Re: plot no. 60, R.S. 4

Plot No. 60

Sheet No. R.S.4 Narasimham Qr.

BUILDING SURVEYOR'S REPORT.

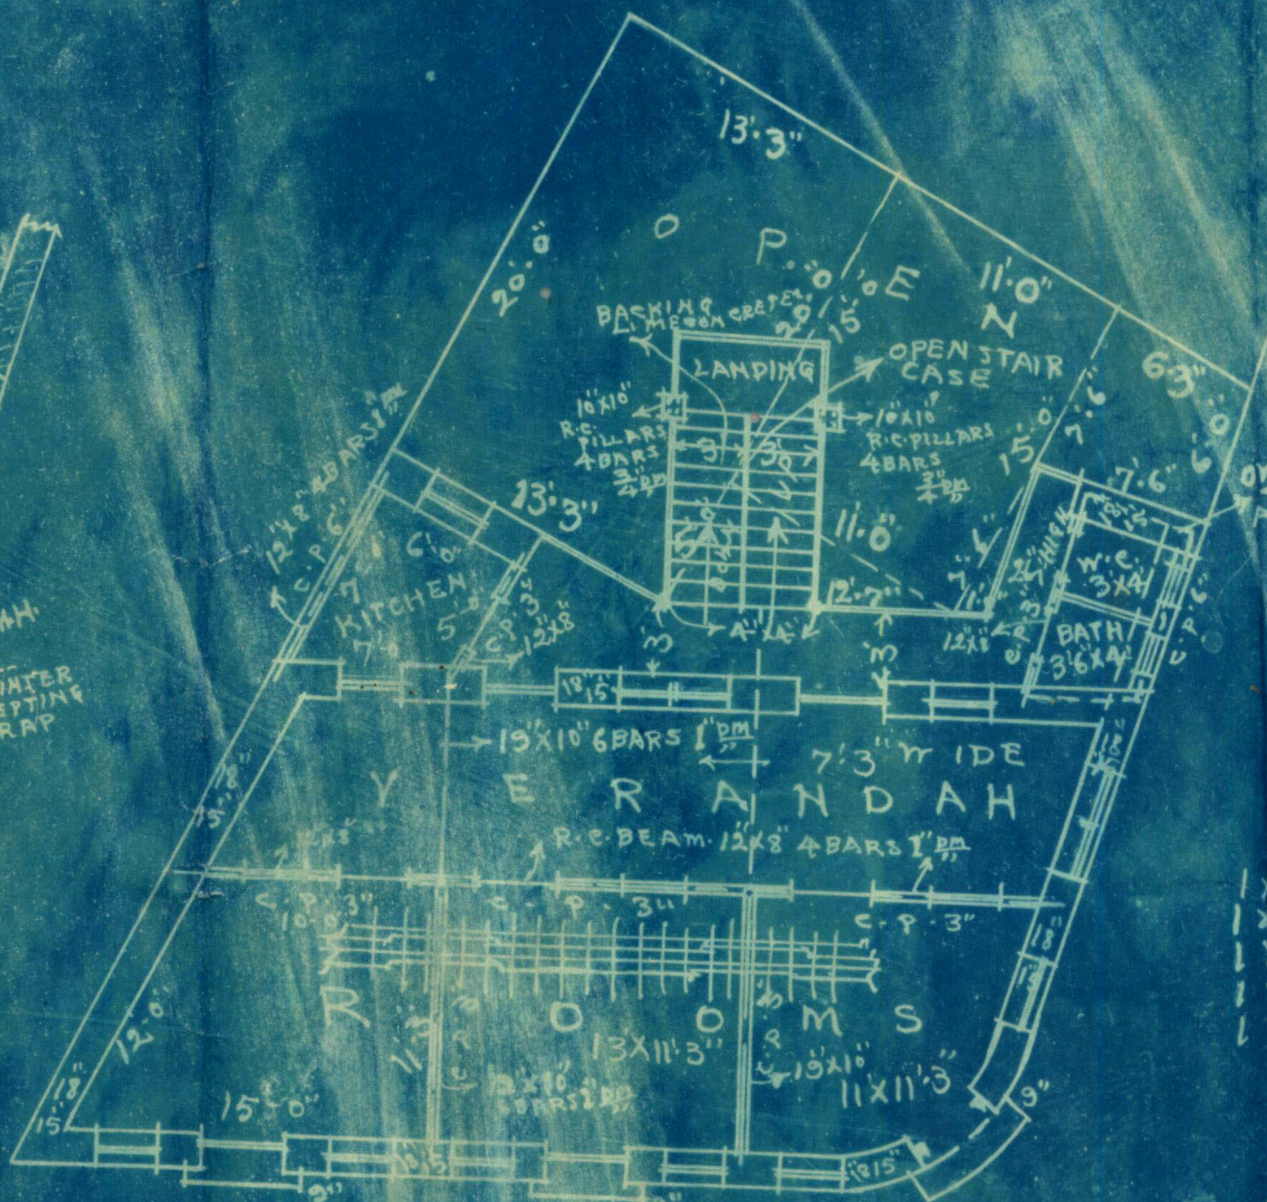
The owner proposes to erect upper floors over the ground floor, which had an excess built up area of 1.2 sq. yds. Though this was recommended to the Co. to be condoned, I find there are no orders re. the same in the file. Your orders are now requested before plans ^{finally} can be approved.
(File put up).

Don't you think pillars

at x x are necessary

Not approved
23/5

1st floor is already
existing without the
pillars as the main R.C.
beams are adequate to
carry the load without any
pillars
